Block 16 Section 10

1.0 Context and Character

Functionality and build quality Mixed uses

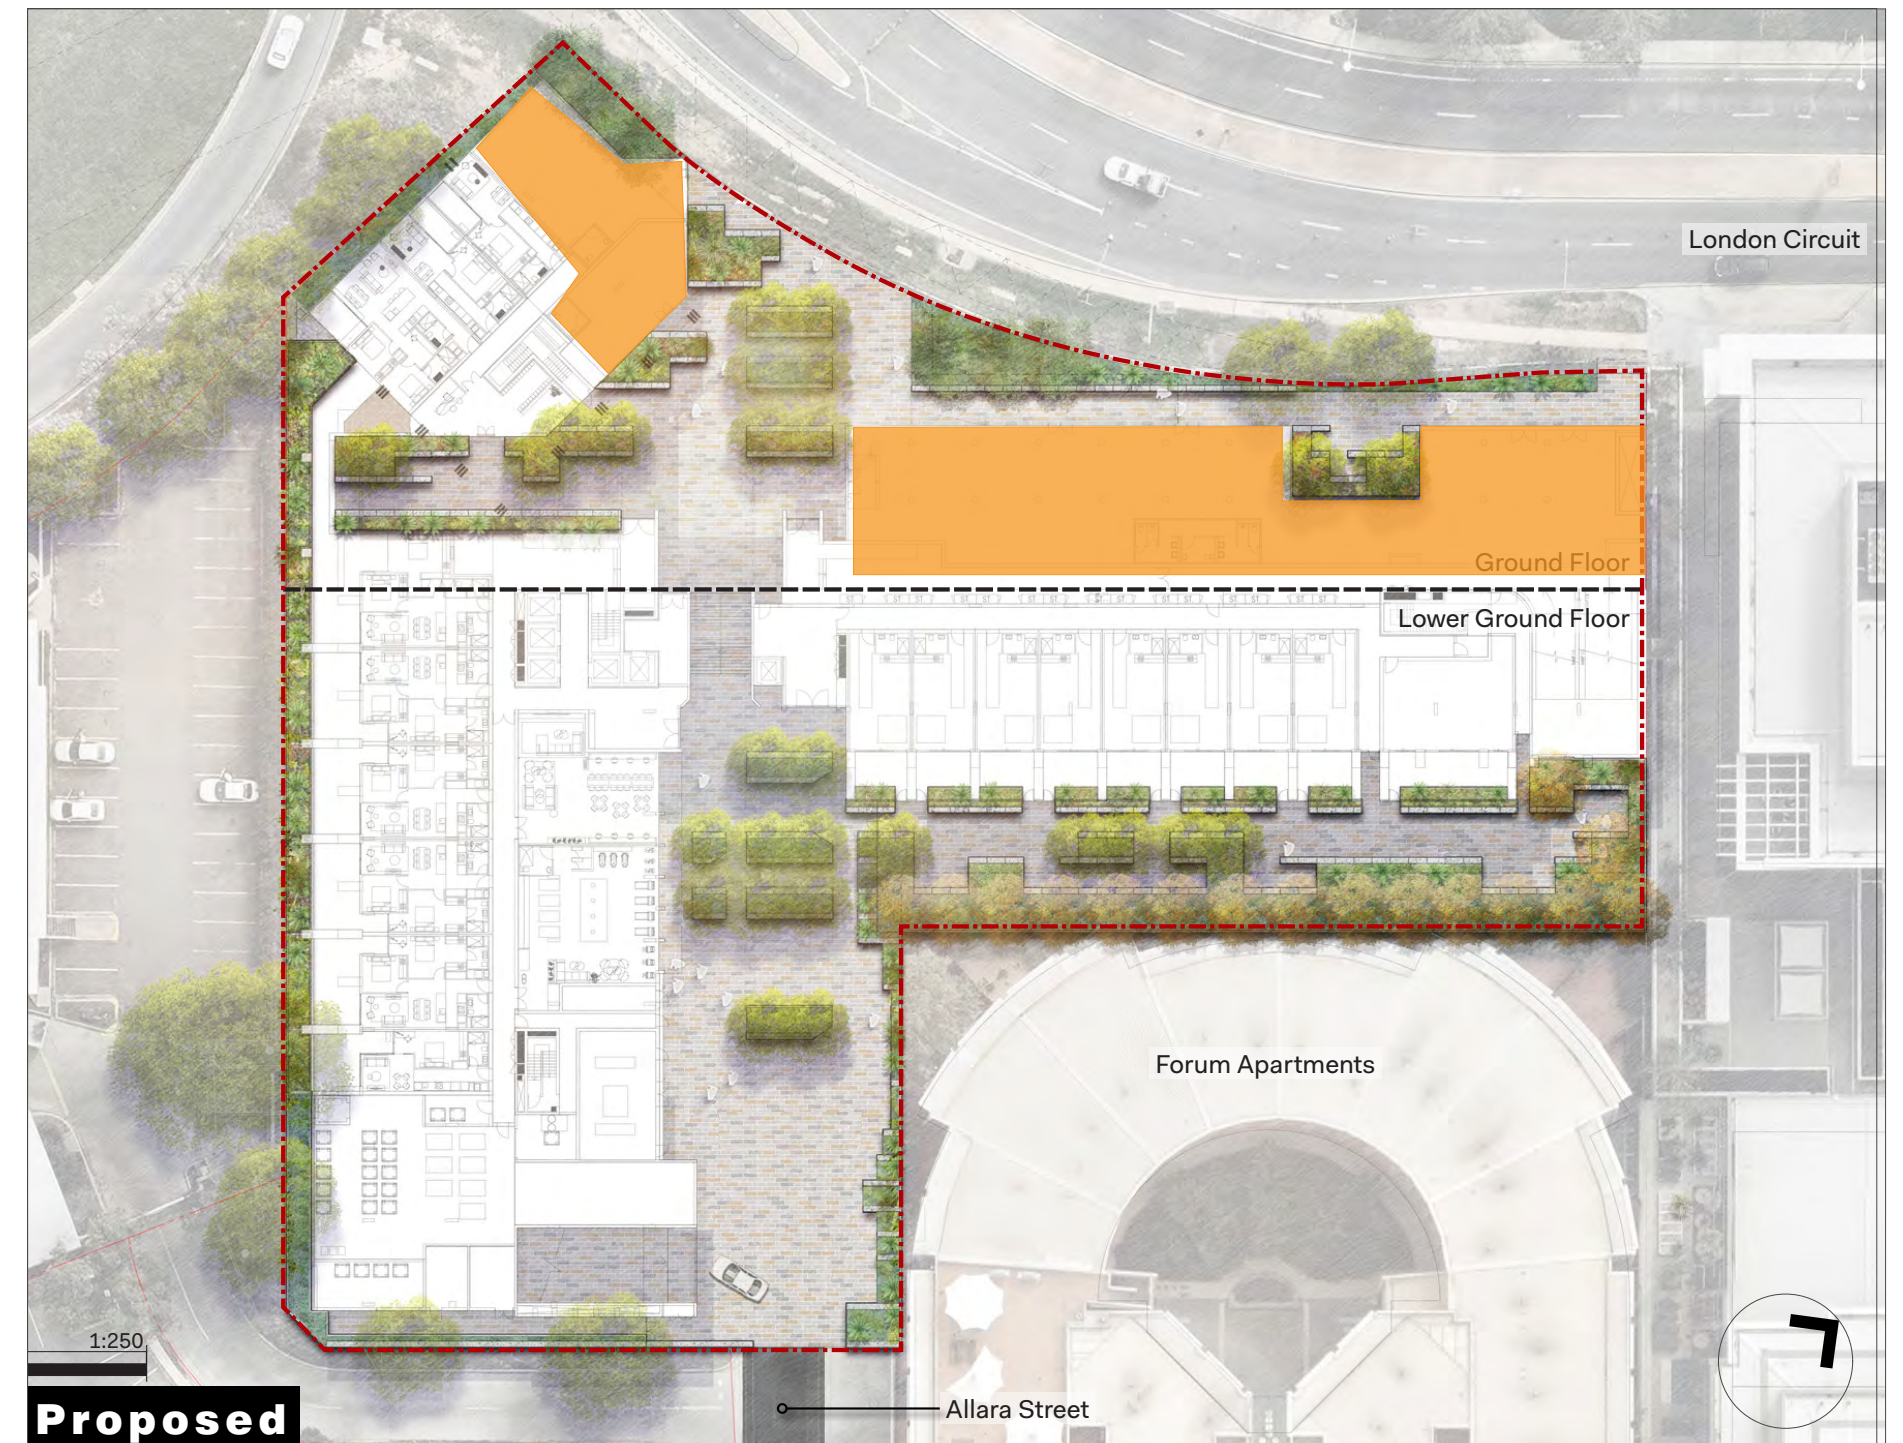
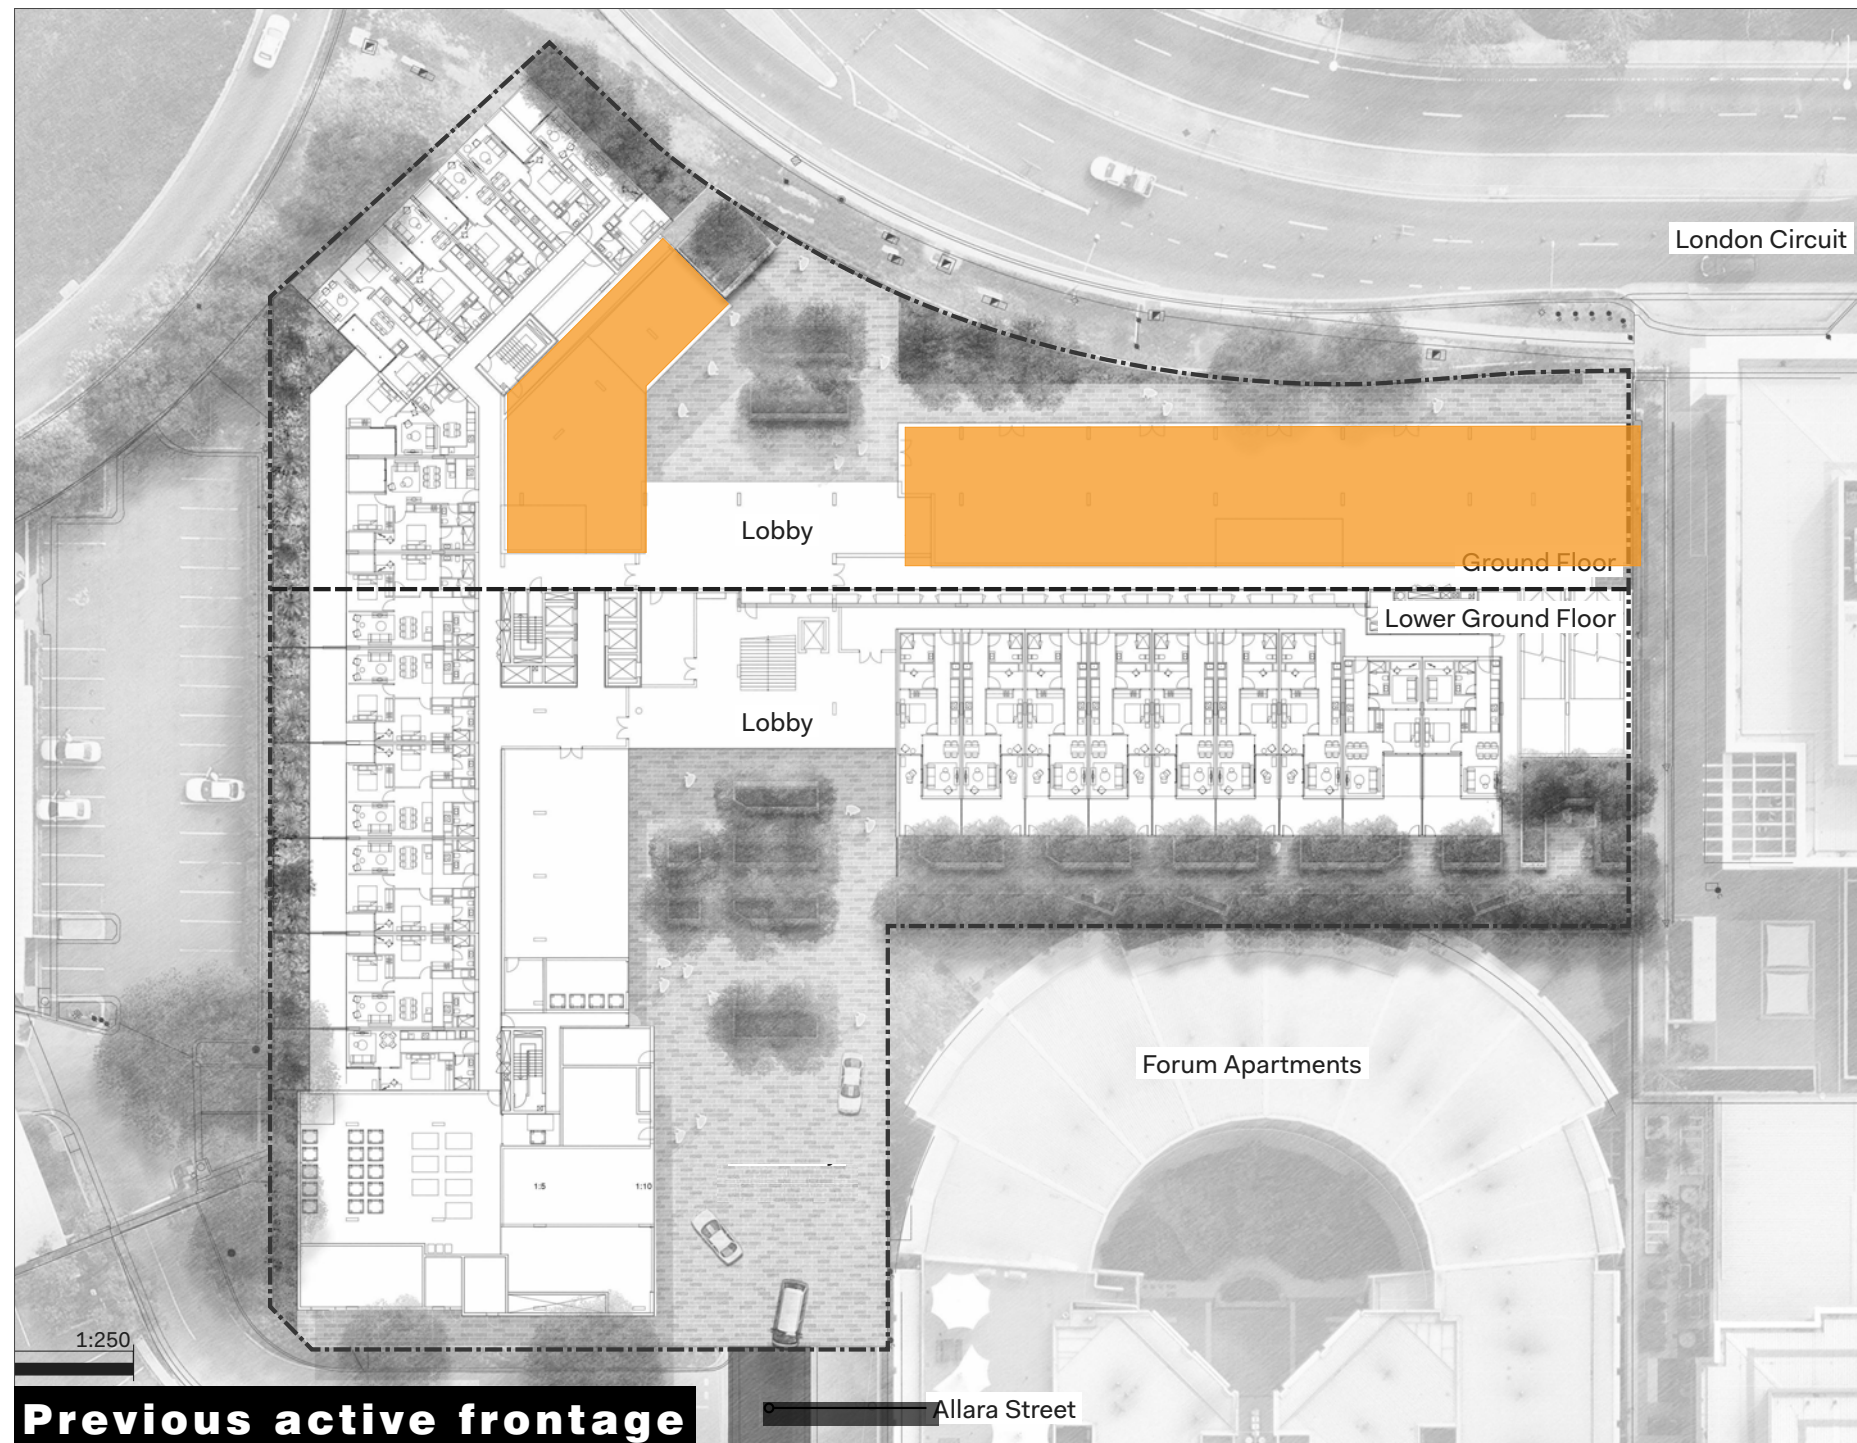
6.1 The Panel continues to encourage the proponent to explore opportunities for an increased mixed-use outcome for the site. Noting the likely location of a future light rail stop to the southern alignment of London Circuit, the Panel considers that a stronger interaction with the street should be re-evaluated by the proponent. Furthermore, the Panel considers that increased offerings such as commercial and/or offerings able to support future adaptive reuse could provide desirable activation to the proposal. This may include extending the commercial floorplate depth (i.e. to accommodate traditional office tenancies) and introducing commercial components at the lower-level frontage to Allara Street.

Functionality and build quality Public space activation

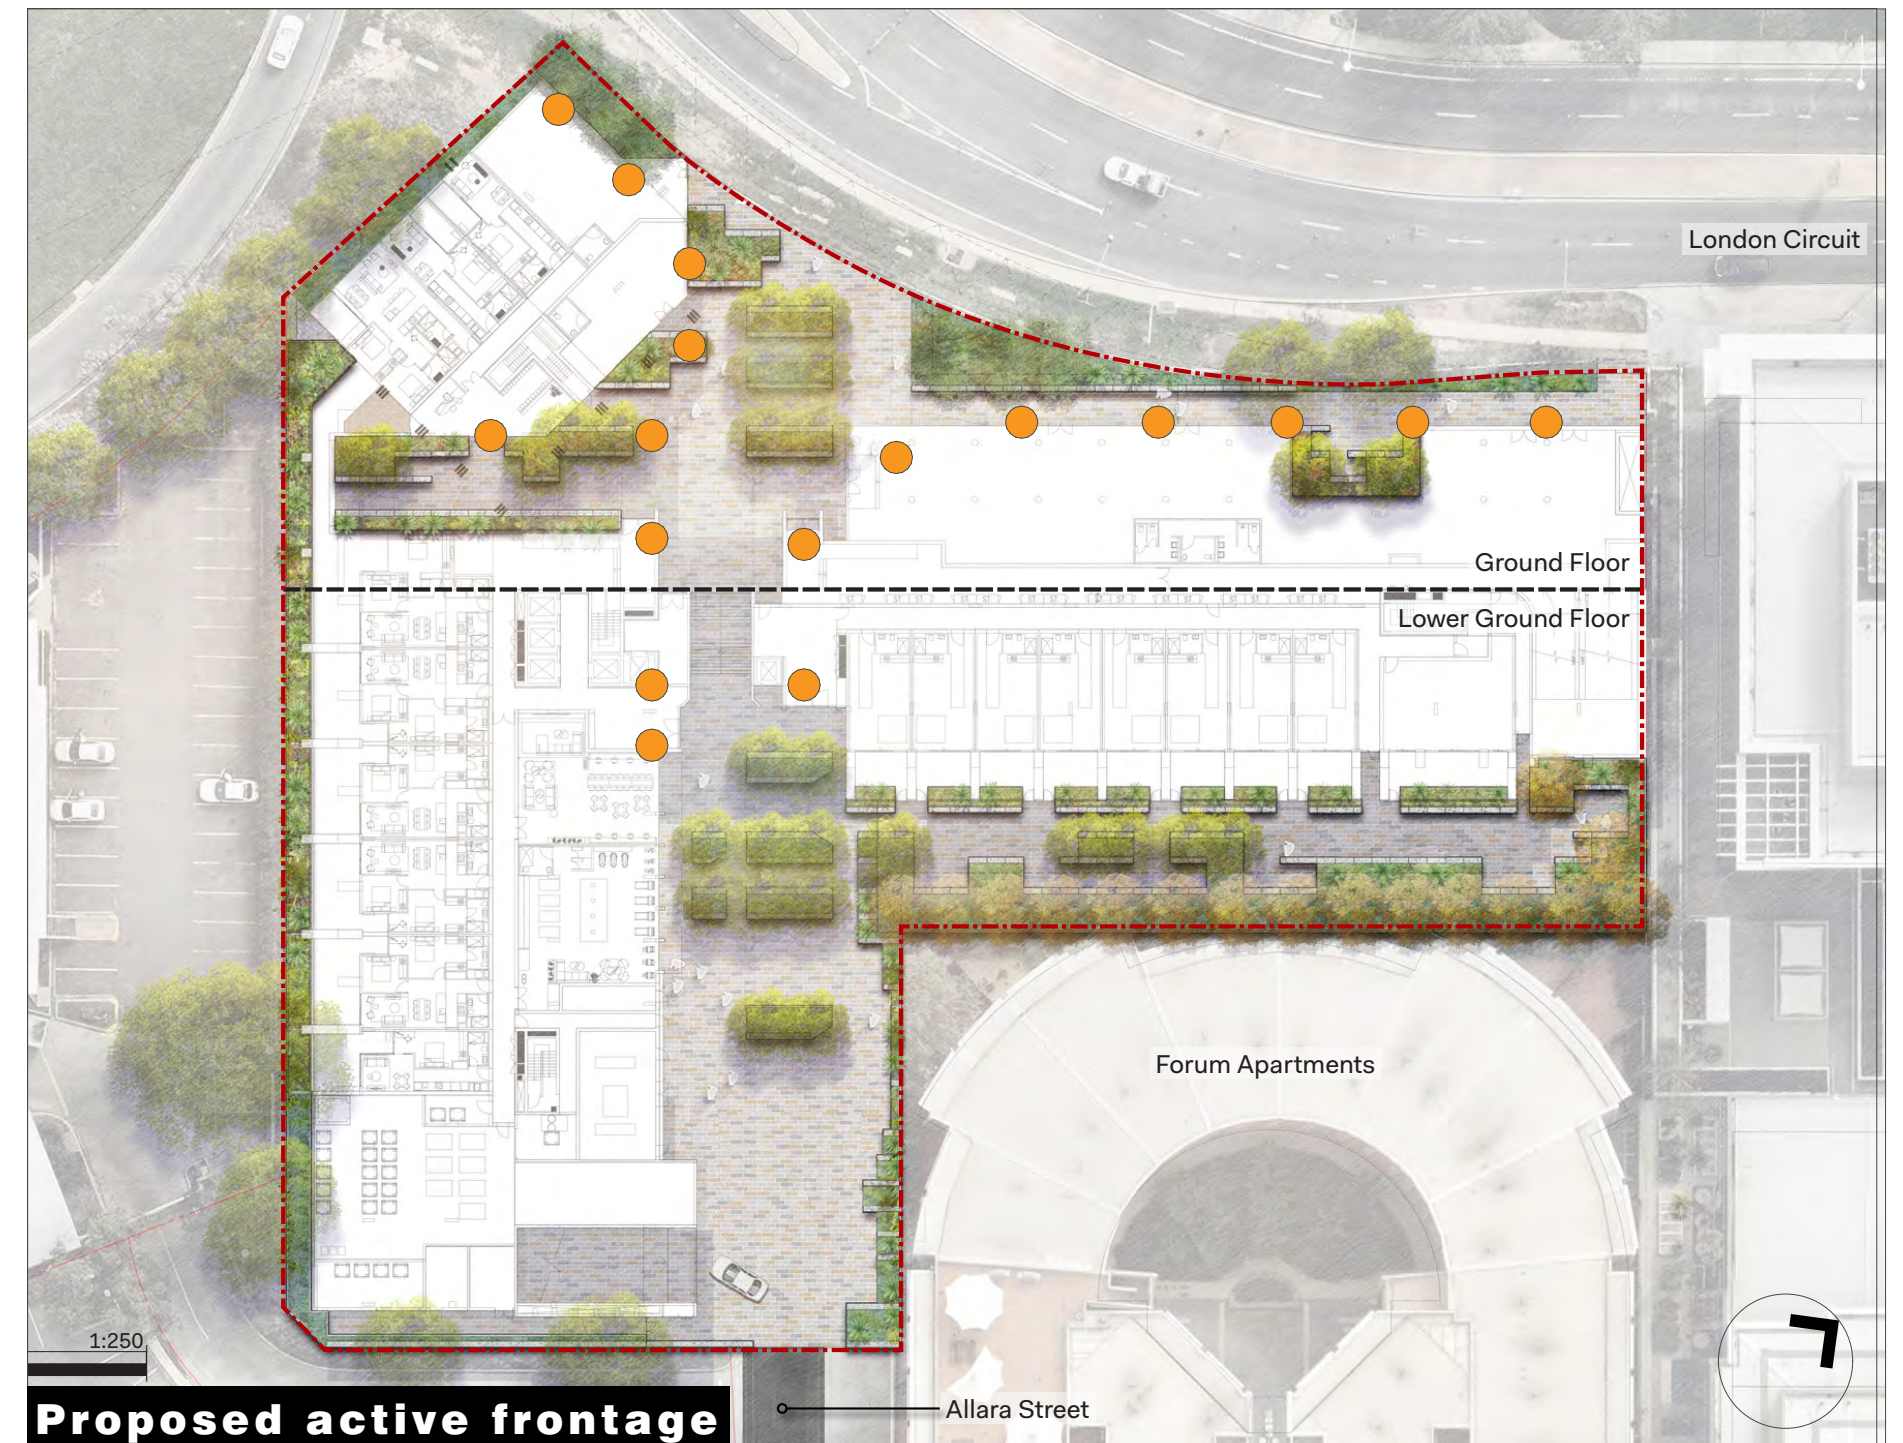
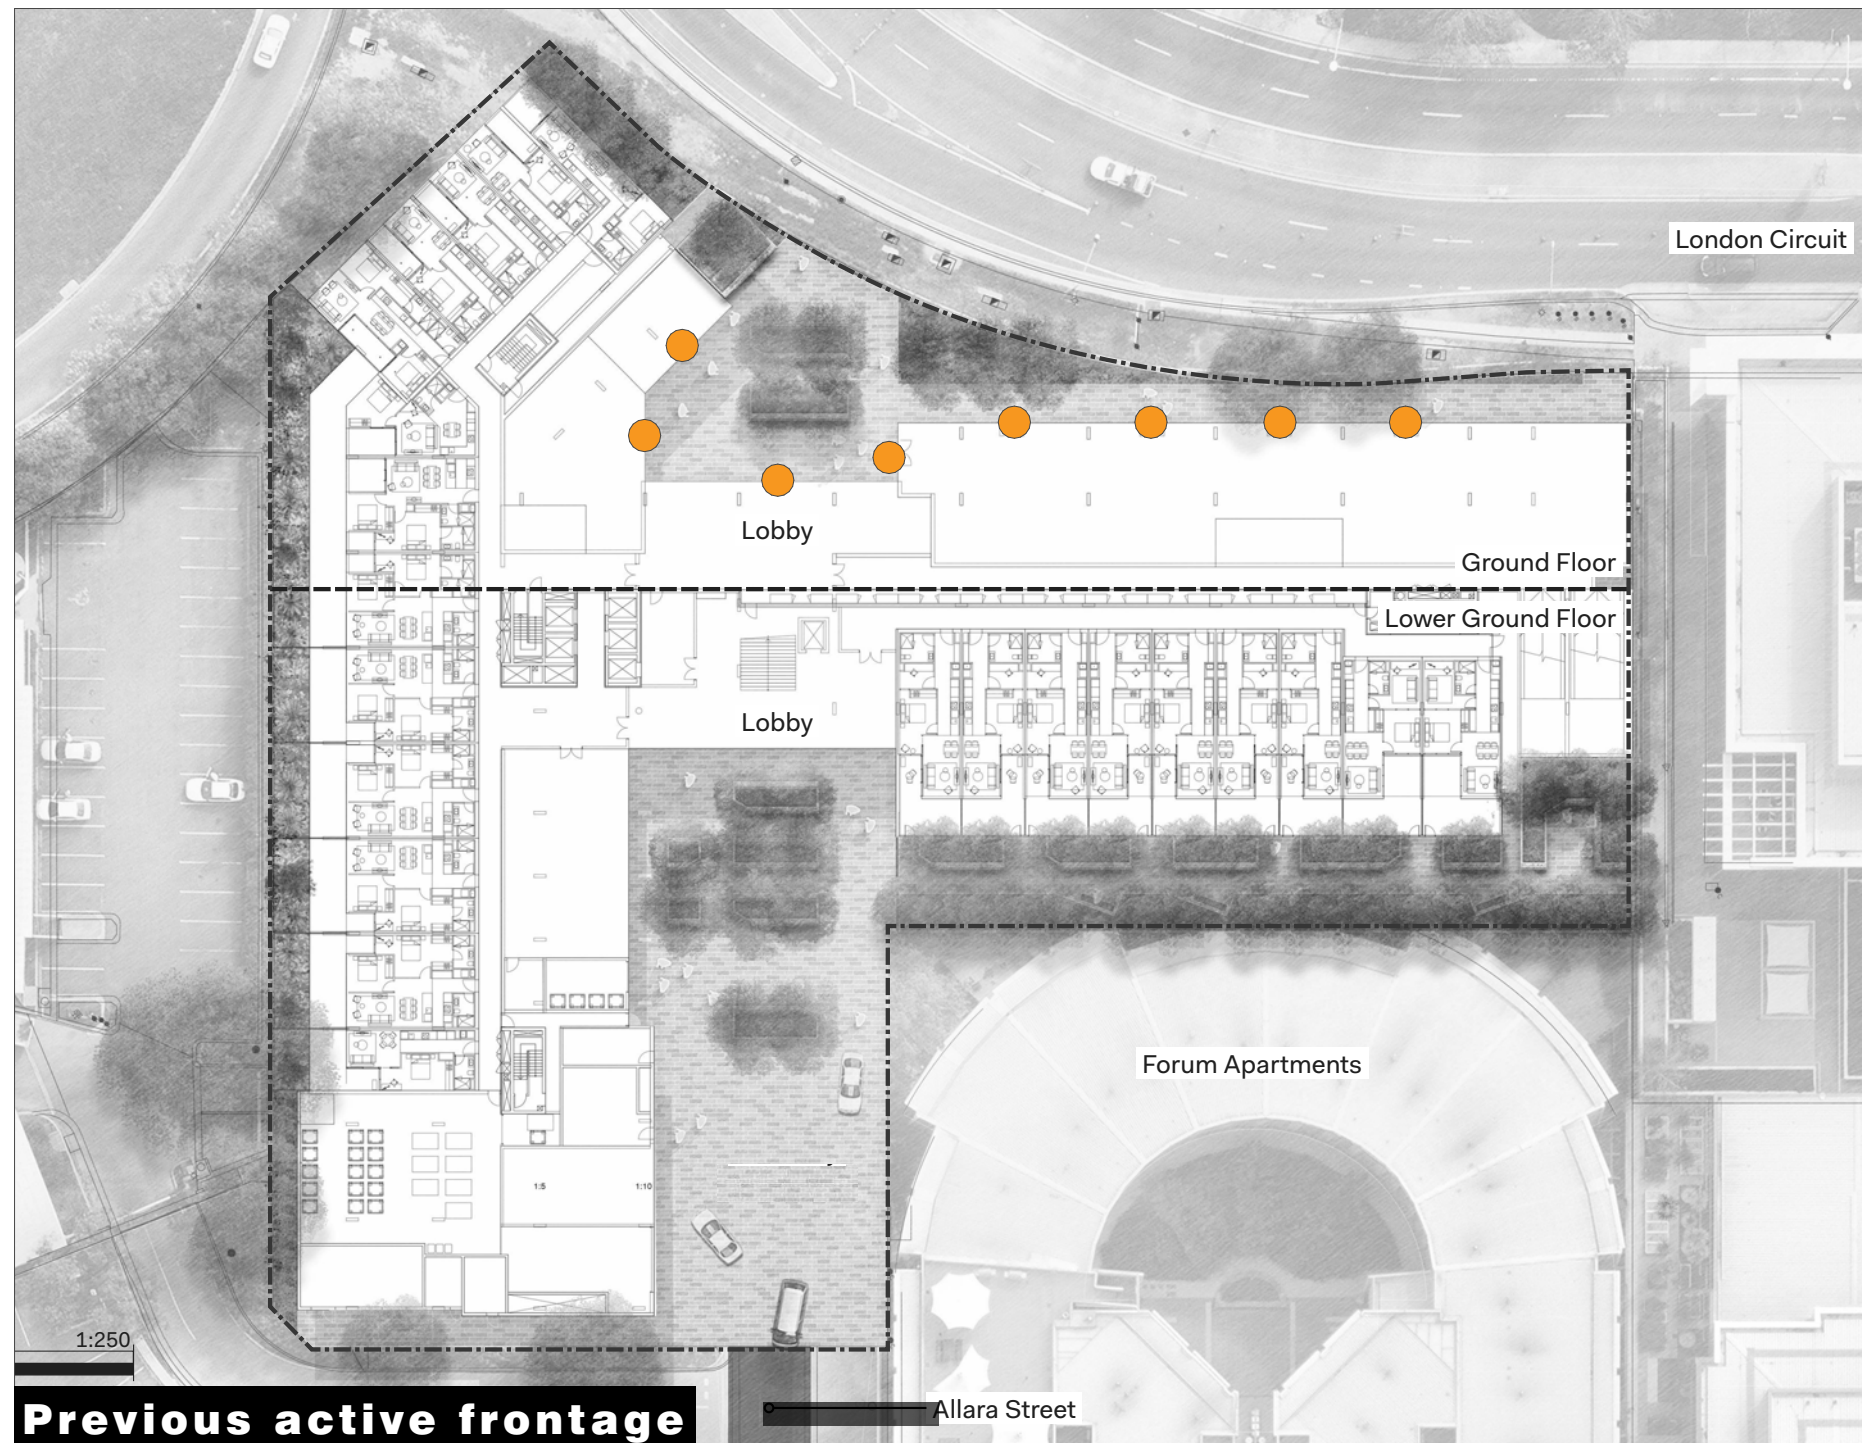
6.1 The Panel continues to encourage the proponent to explore opportunities for an increased mixed-use outcome for the site. Noting the likely location of a future light rail stop to the southern alignment of London Circuit, the Panel considers that a stronger interaction with the street should be re-evaluated by the proponent. Furthermore, the Panel considers that increased offerings such as commercial and/or offerings able to support future adaptive reuse could provide desirable activation to the proposal. This may include extending the commercial floorplate depth (i.e. to accommodate traditional office tenancies) and introducing commercial components at the lower-level frontage to Allara Street.
